NRDC Input on ENERGY STAR Version 9.0 Draft 1 TV Specification

October 29, 2020

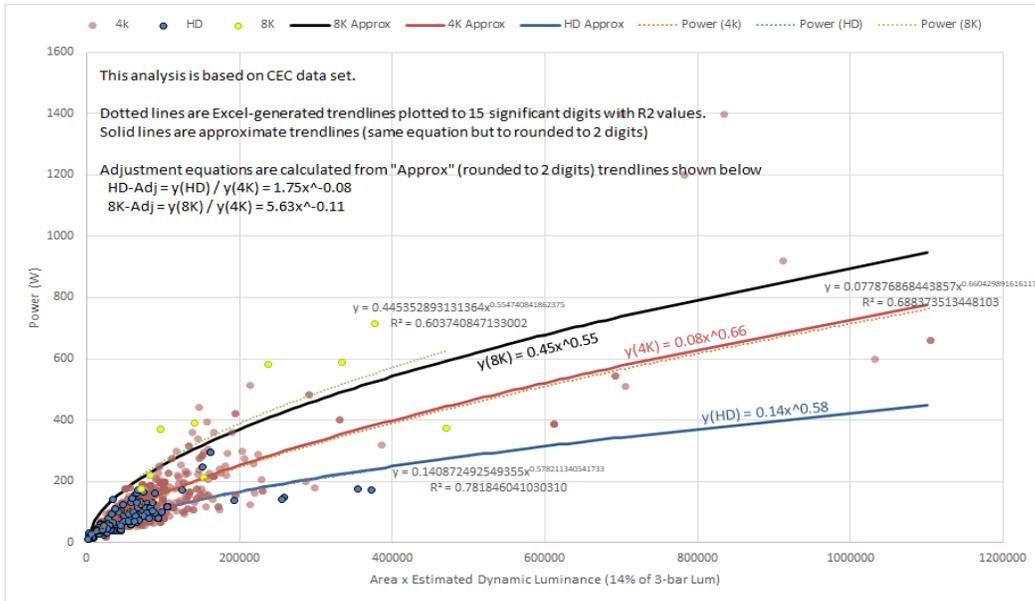
The proposed specification appears to be insufficiently stringent for small to mid-sized TVs. Per EPA’s analysis shown below, the pass rates for TVs <52.5 inches, which likely represents about half of all TV sales, is between 45 and 50%. This is way too high for an ENERGY STAR specification.

- a) Find a way to set the pass rate for each screen size bin to 25% or lower
- b) Provide a breakout by screen resolution to determine what % of HD, 4K and 8K TVs pass. The current adders seem overly generous.
- c) Provide supporting data that shows the annual energy use of the tested TVs compared to the proposed specification levels.
